TENNESSEE VALLEY AUTHORITY

June 25, 1985

Please refer to your letter to H. G. Parris dated September 14, 1984 which requested that additional information be provided on the Watts Bar Safety Parameter Display System (SPDS) in the areas of instrumentation and control systems and human factors engineering. TVA's letter of March 27, 1985 provided the requested information pertaining to instrumentation and control systems. Enclosed is the requested information regarding human factors engineering.

WATTS BAR NUCLEAR PLANT
HUMAN FACTORS ENGINEERING INFORMATION

Number: F-0	Title: CRITICAL SAFETY FUNCTION STATUS TREES	Rev. Issue/Date: HP/LP, REV. 1 1 Sept., 1983
----------------	--	--

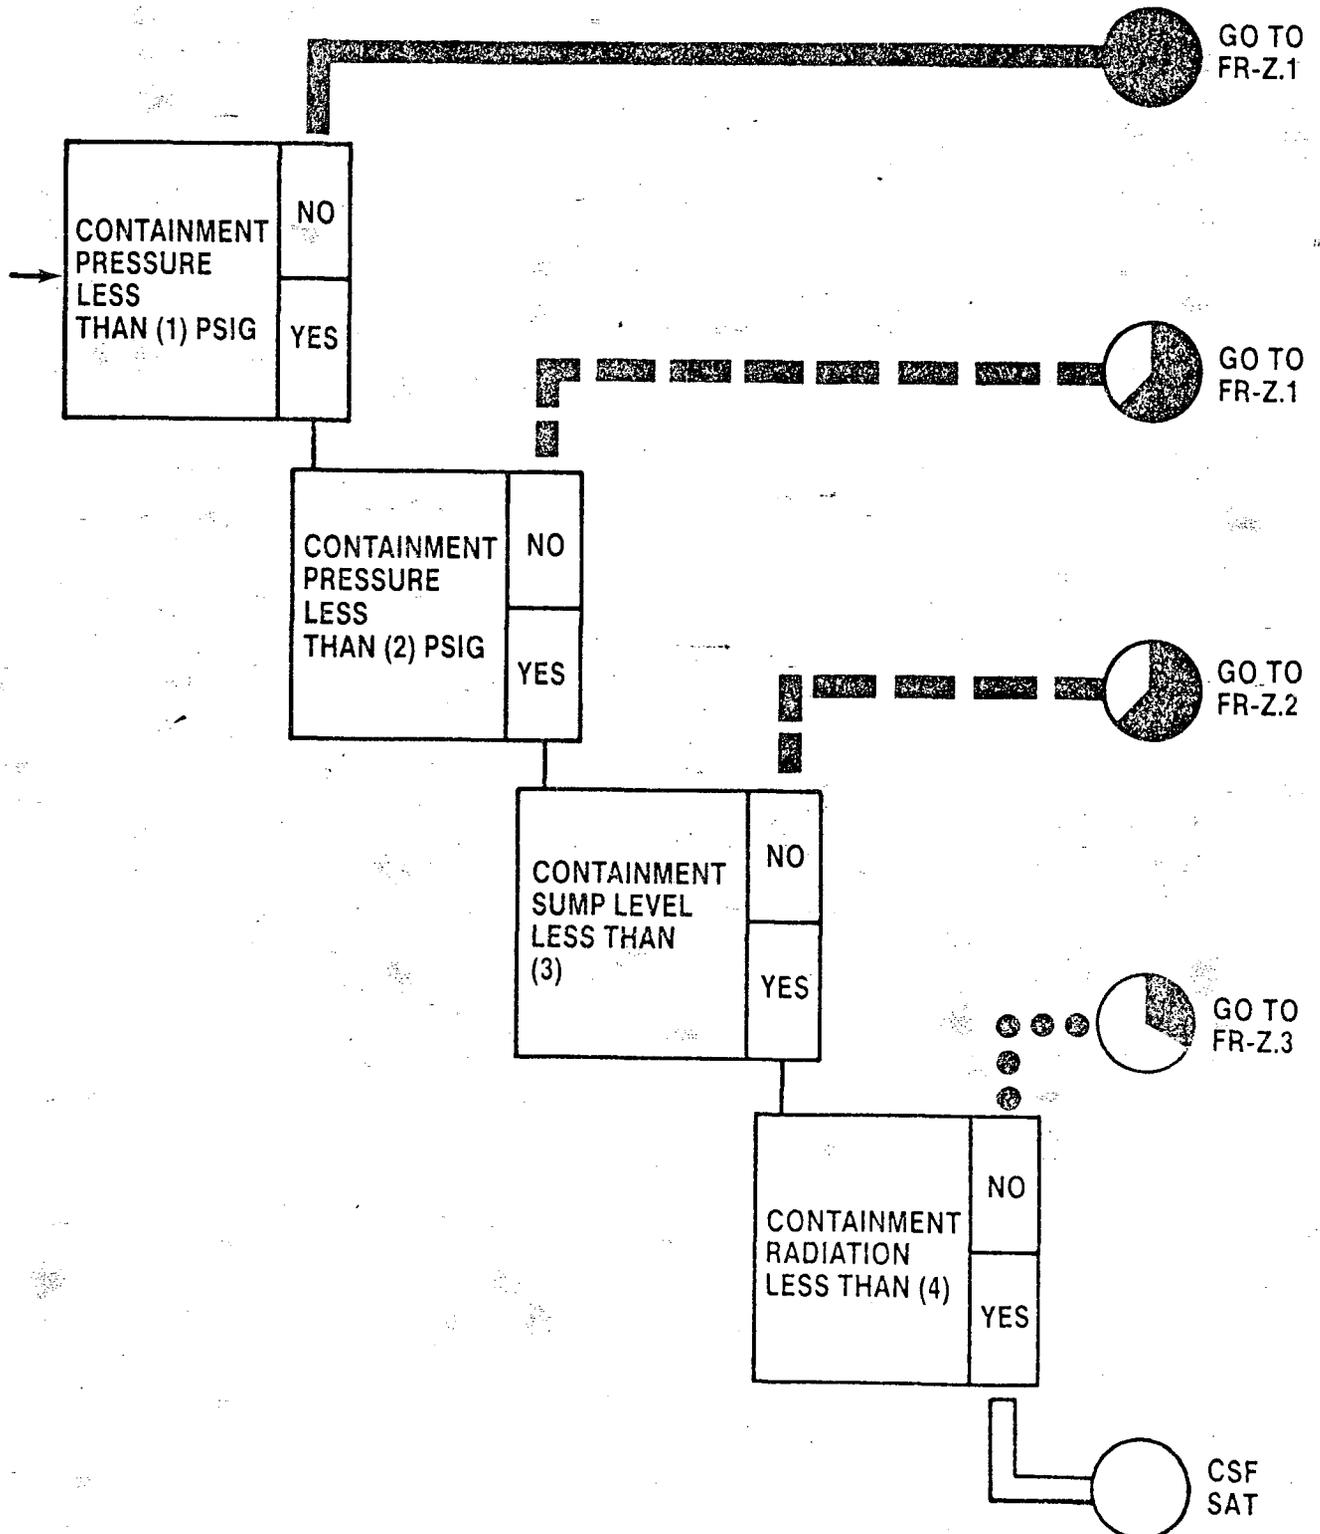
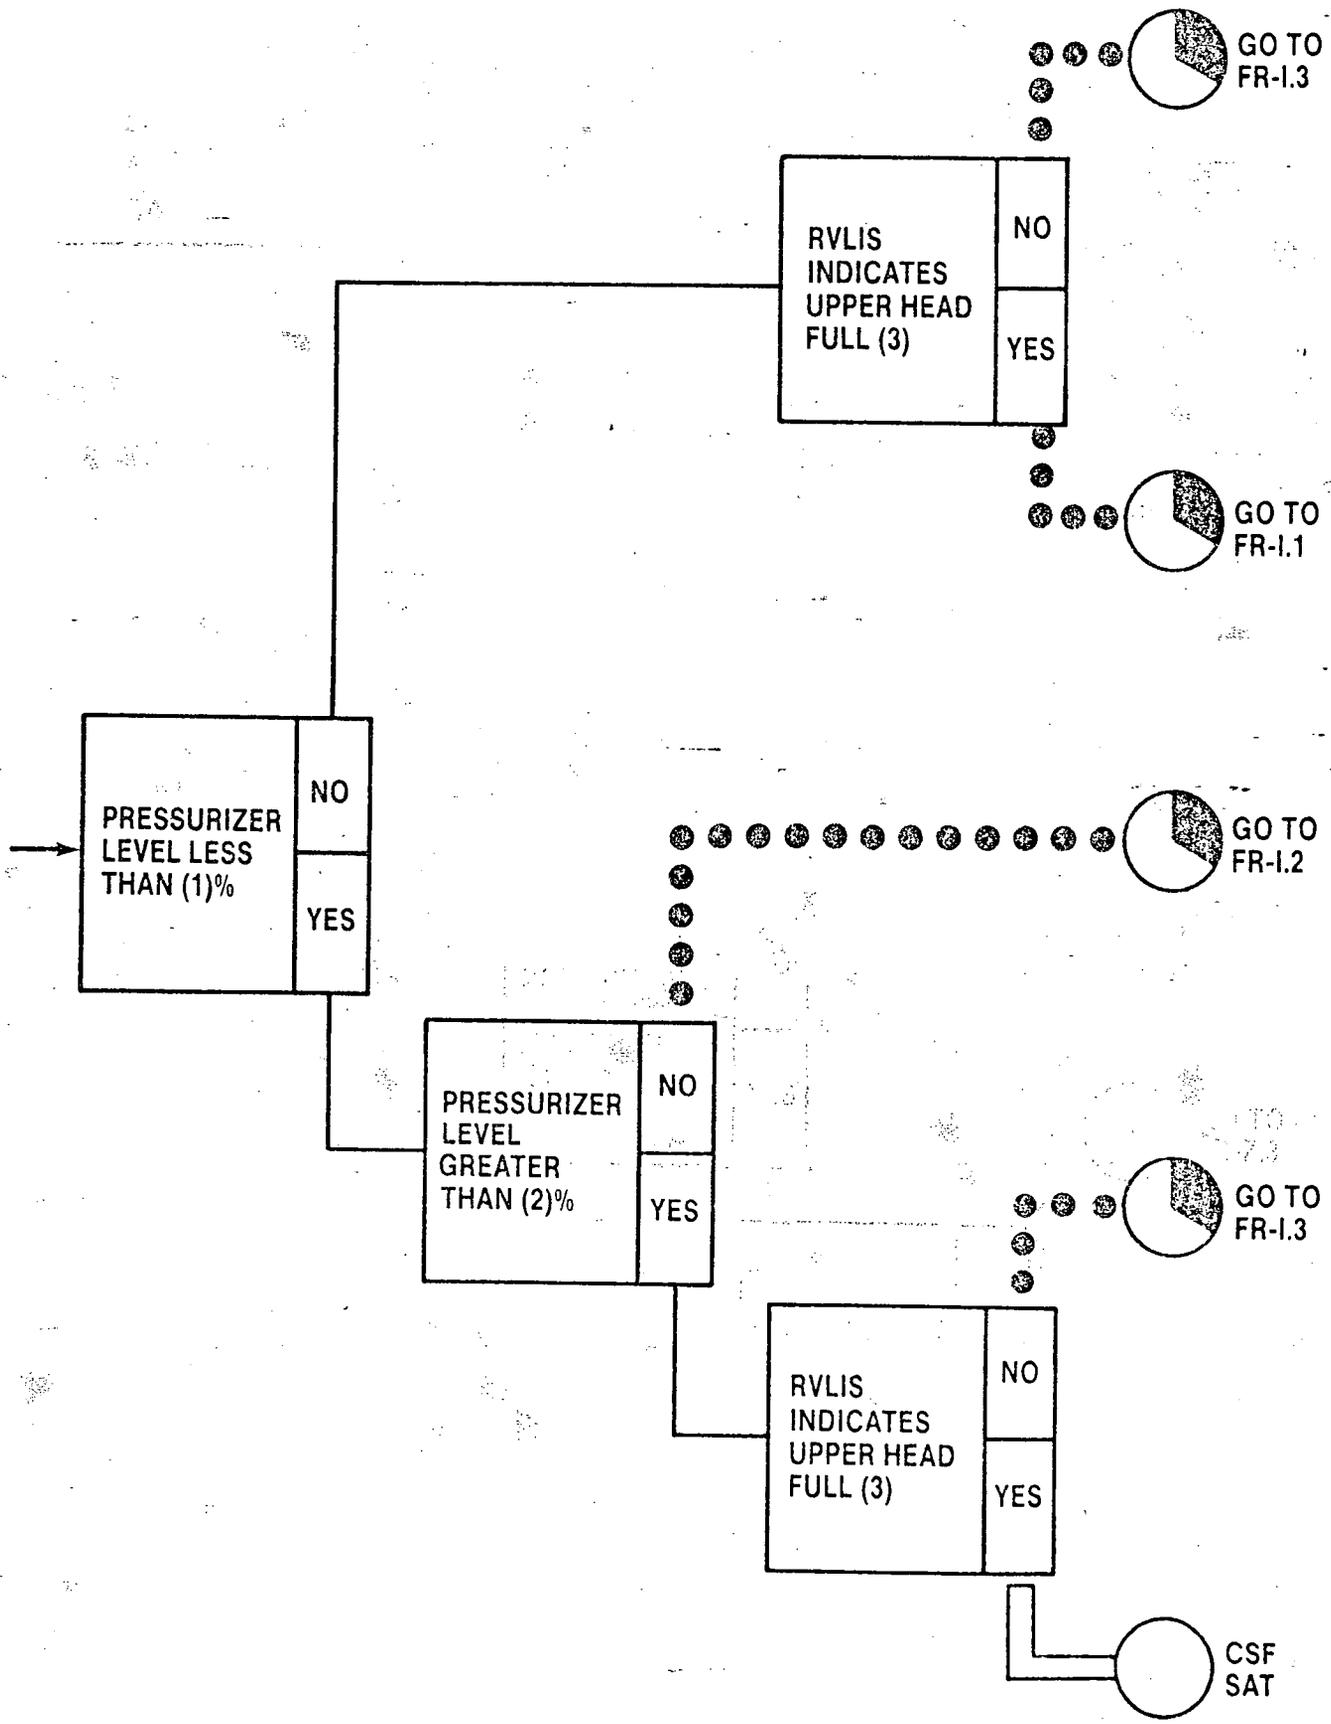
Provide a description of the display system, its human factored design, and the methods used and results from a human factors program to ensure that the displayed information can be readily perceived and comprehended so as not to mislead the operator.

The Safety Parameter Display System (SPDS) consists of the block type critical safety function status trees from the upgraded Westinghouse Owners Group (WOG) Emergency Response Guidelines (ERGs). Documentation for these status trees "Emergency Response Guidelines Revision 1" were transmitted to Hugh L. Thompson, Jr., Director, Division of Human Factors Safety, by the Westinghouse Owners Group on May 4, 1984.

Each tree uses several blocks containing questions with a yes or no output which leads to a status. When a status tree branch is not satisfied, it directs the operator to an appropriate function restoration guideline.

Six generic status trees from the WOG ERGs are attached. These trees will be converted to plant-specific trees for Watts Bar. The different branches are color coded to show the operator how serious any challenge is to a critical safety function. The ordering of the trees also defines priorities. The colors in order of priority are: red (solid line), magenta (dashed line), yellow (short dashed line), and green (double line).

When any status tree is displayed, colors are shown in a designated area, giving the status of the other five trees.

The critical safety function status trees have been developed using human factors principles. When the SPDS system is operational, the control room design review team will make a human factors review on the status tree displays.
